SUBJECT: INDEPENDENT QUALITY REVIEW GROUP COMMENTS ON THE ABB-COMBUSTION  
ENGINEERING (ABB-CE) SYSTEM 80+ CERTIFIED DESIGN MATERIAL (CDM) AND  
ABB-CE STANDARD SAFETY ANALYSIS REPORT (CESSAR-DC)

An Independent Quality Review Group has reviewed the CDM and the CESSAR-DC, and provided their comments to the staff inspections, tests, analyses, and acceptance criteria (ITAAC) task groups. The ITAAC task groups have reviewed the comments, and those that require action by ABB-CE are contained in the enclosure.

CESSAT  
 FIGURE 9.2.10-1

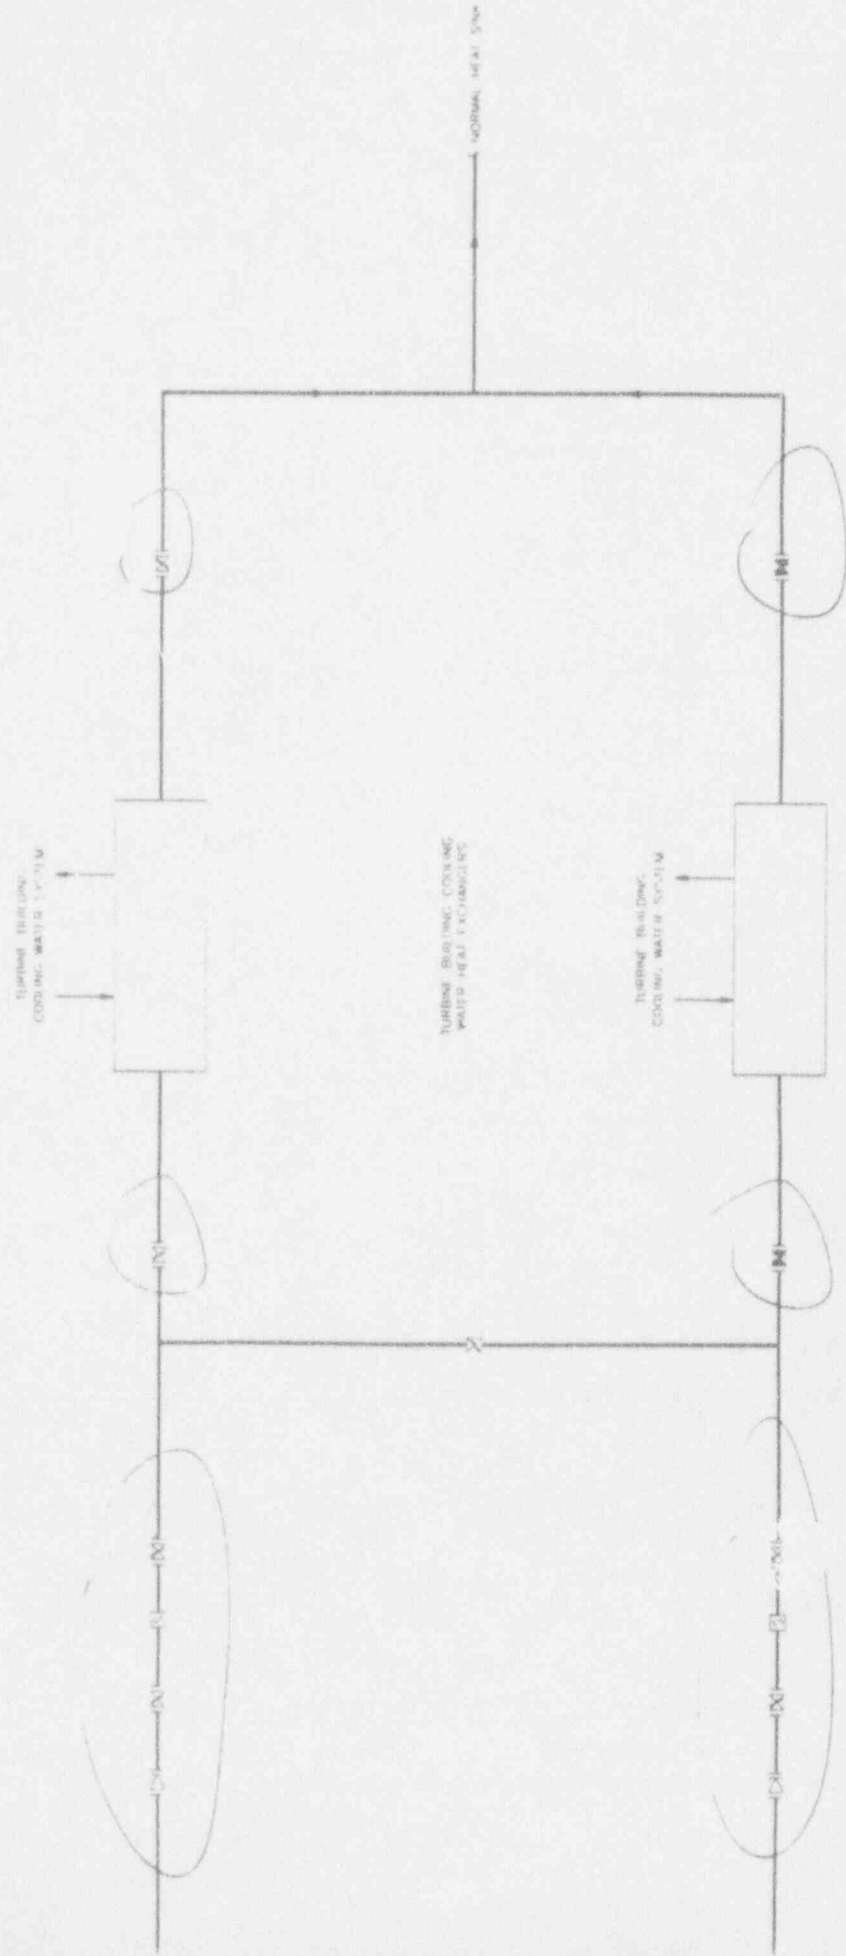
No.	Comments	Cat.	Resolution
1	CESSAR Figure 9.2.10-1 used valve symbols that are not defined in accordance with the symbols and legends of Figures 1.7-1 and 1.7-2. Please clarify.	1	Agree - pass to AIR-CE.

FIGURE 2.7.21-1  
CONTAINMENT PURGE VENTILATION SYSTEM (LOW PURGE)

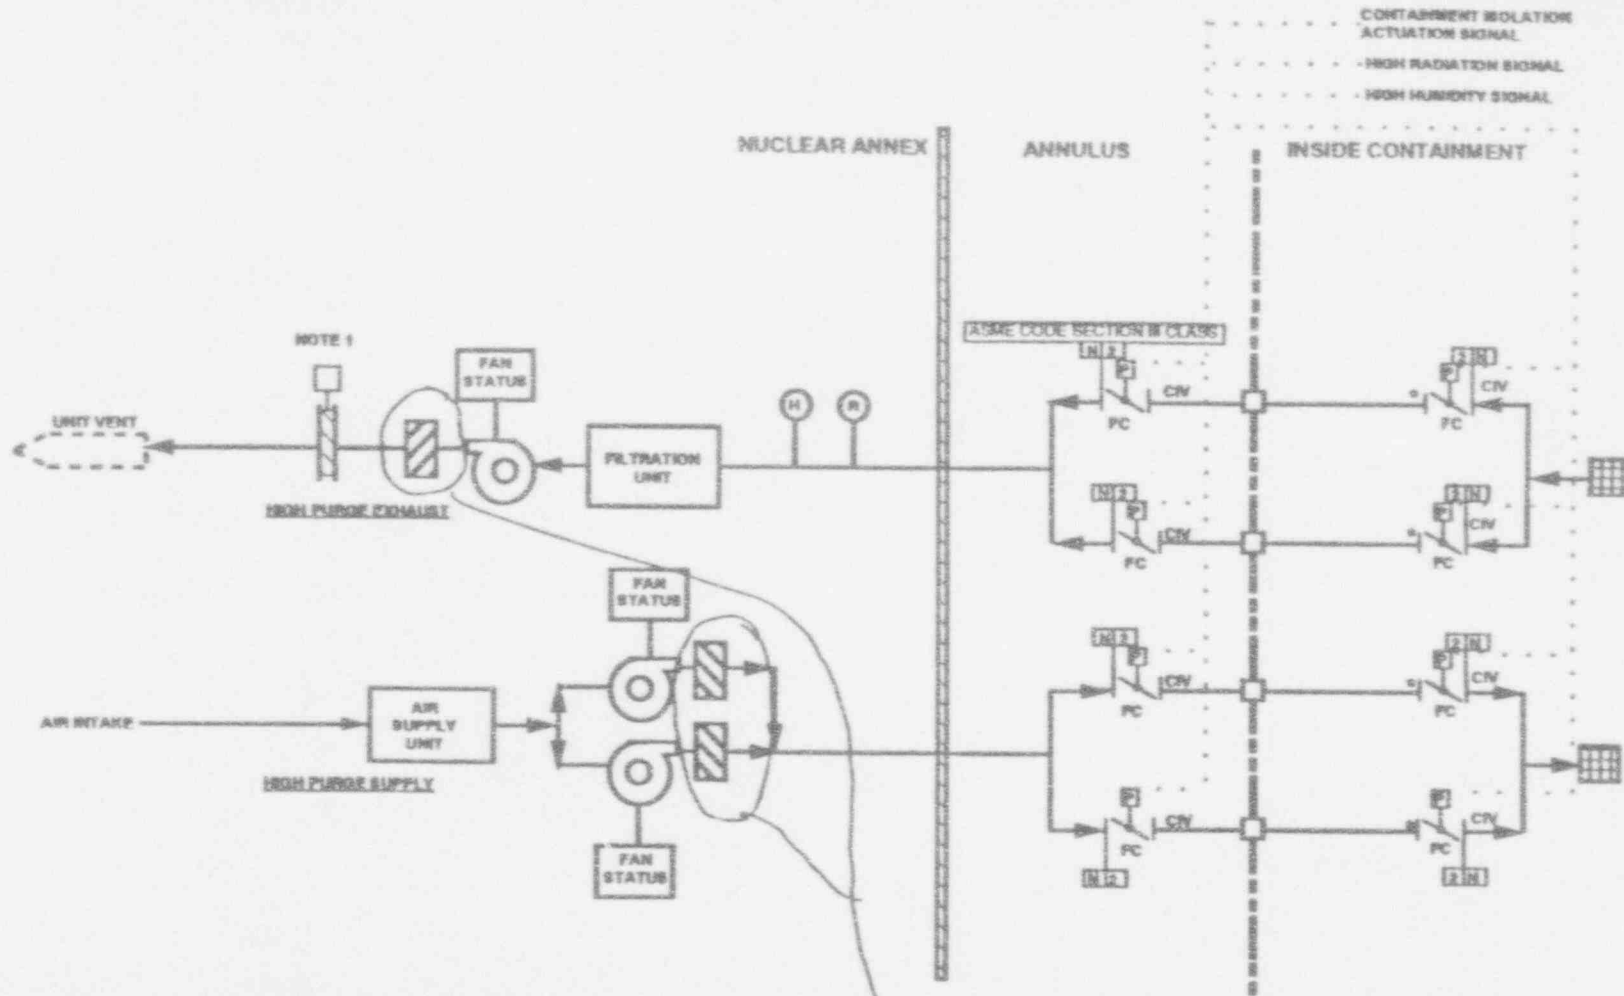
No.	Comments	Cat.	Resolution
1	Figure 2.7.21-1 and -2 should have back draft dampers on the discharge side of fans. CESSAR figure 9.4.6.		<p>AGREE.                      FIGURE 2.7.21-1 AND -2                      SHOULD SHOW CORRECT                      SYMBOLS FOR                      BACK DRAFT                      DAMPERS.</p>

*should be backdraft dampers not Louvers*

FIGURE 2.7.21-2  
CONTAINMENT PURGE VENTILATION SYSTEM (HIGH PURGE)

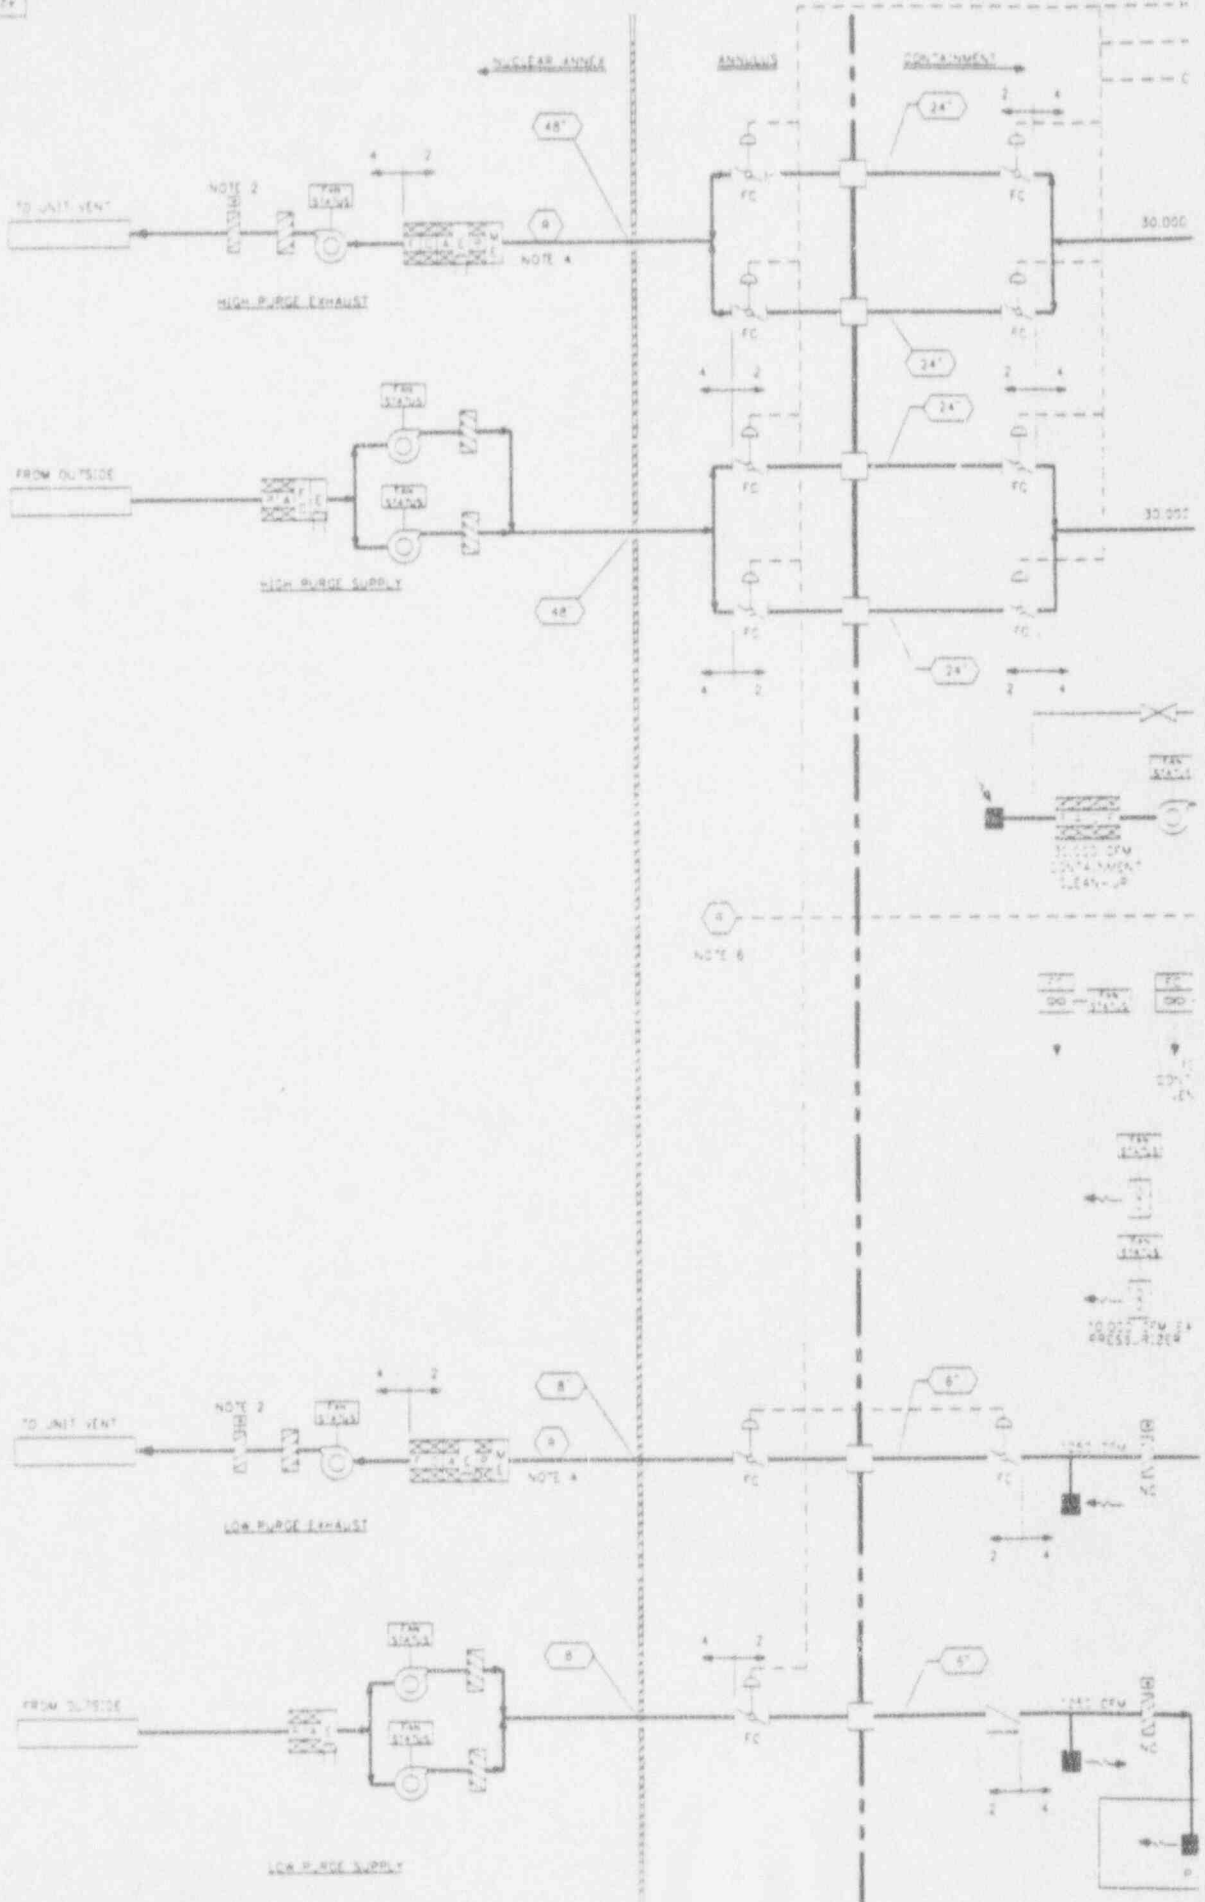
*should be backdraft dampers not louvers*

FIGURE 2.7.22-1  
CONTAINMENT COOLING AND VENTILATION SYSTEM

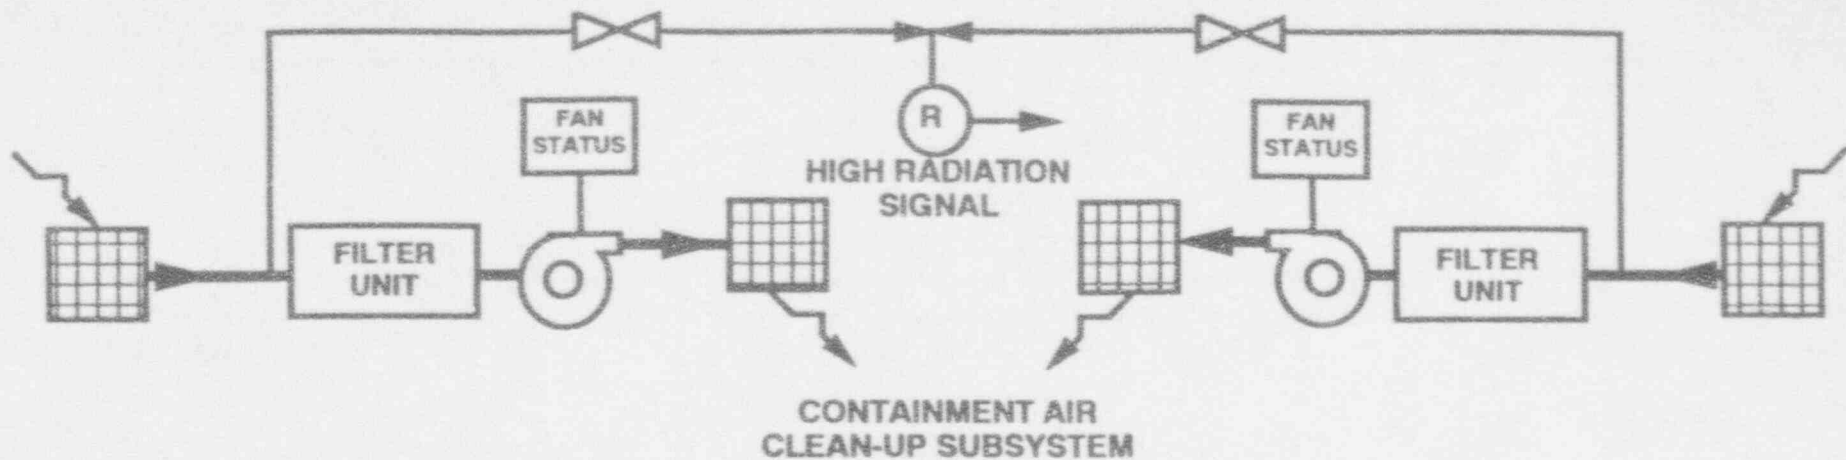
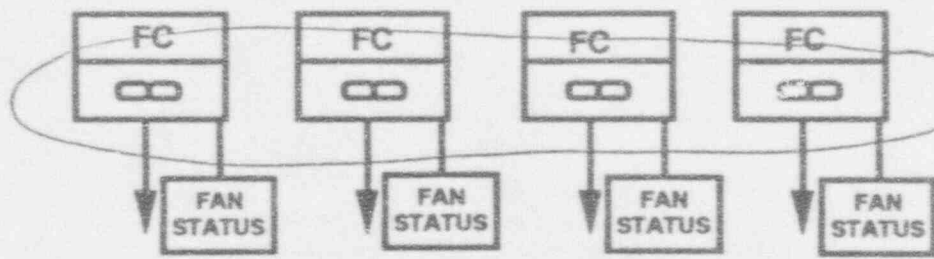
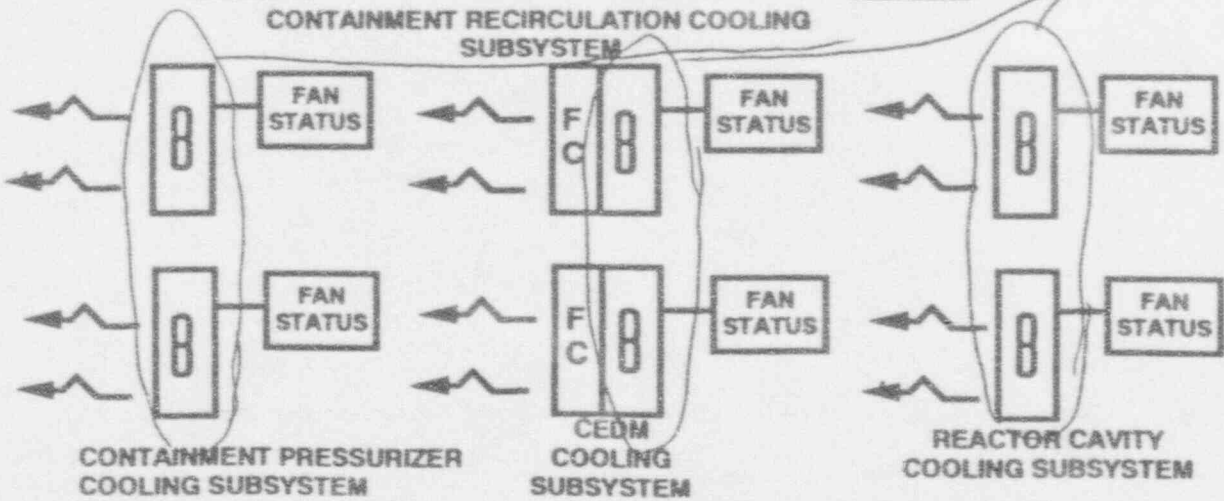
No.	Comments	Cat.	Resolution
1	Figure 2.7.22-1 does not use the standard fan symbol.		<p><u>APPL:</u>                      CDH AND TIGE 2 FIGURES ARE IDENTICAL. THERE IS NO SYMBOL FOR "FAN COIL UNIT" OR "RECIRCULATION UNIT" WITHOUT COIL(S).                      ADDITIONALLY, THESE UNITS ARE NON-SIMILAR. HOWEVER, FOR UNIFORMITY OF SYMBOLS, NEW SYMBOL SHOULD BE ADDED FOR "FAN - COIL UNIT" SHOWING COIL(S) AND FAN IN CDHS LEGENDS AND CESSAR-DC FIGURE 9-9-1.</p>

*not standard*

**FIGURE 2.8.2-1**  
**MAIN STEAM SUPPLY SYSTEM**  
 (ARRANGEMENT SHOWN FOR ONE STEAM GENERATOR)

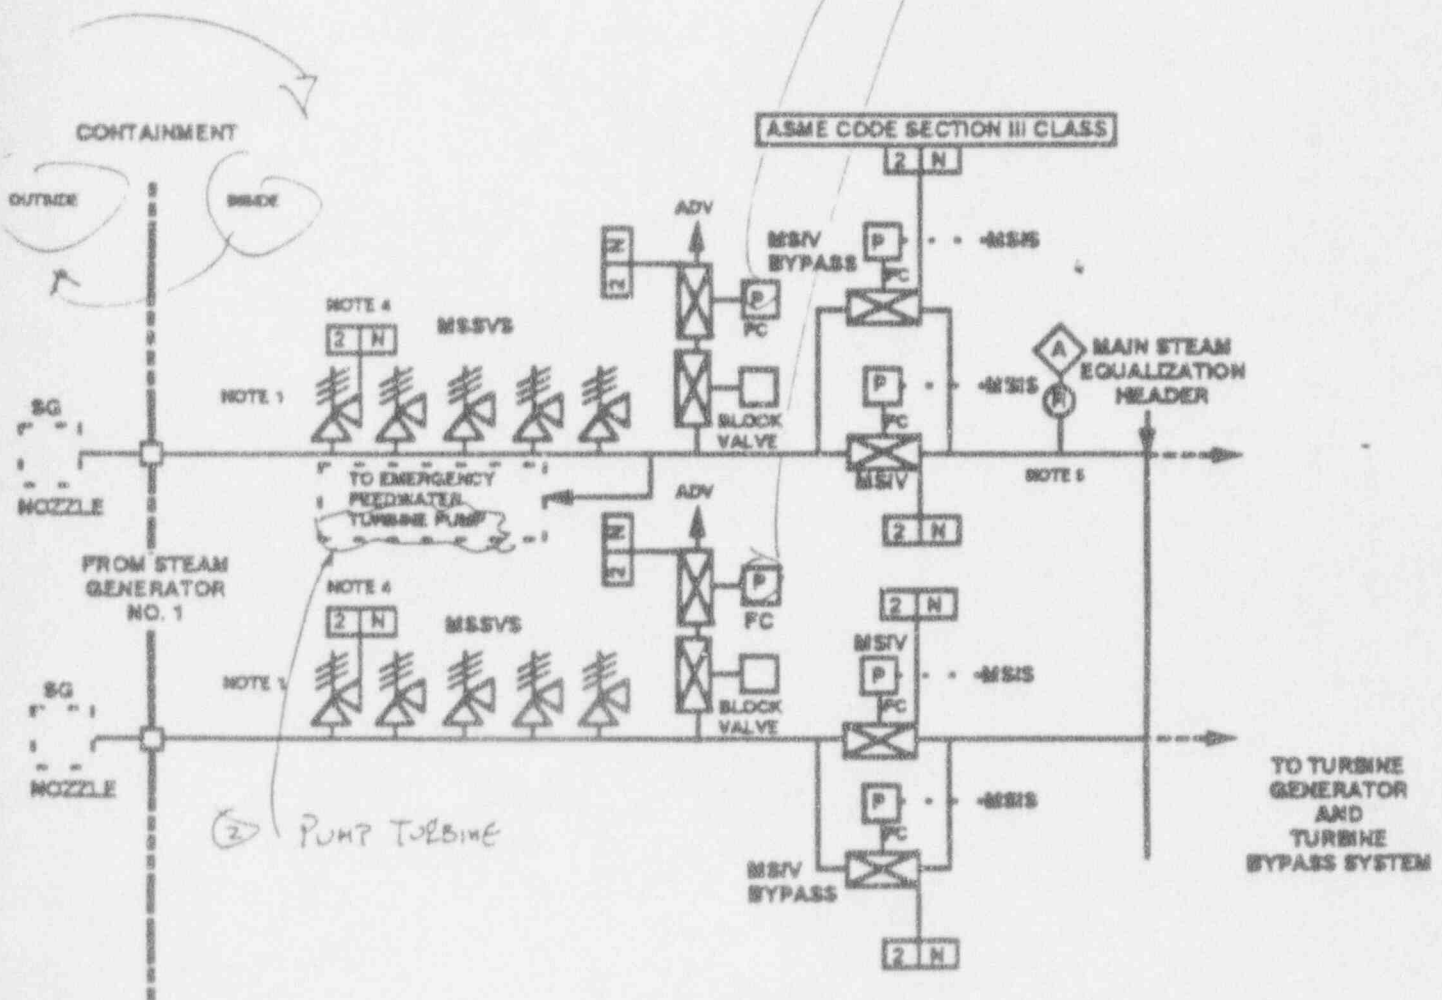
① REVERSE

③ These are Solenoid operated or Flow Diaphragm 10.3.2-1
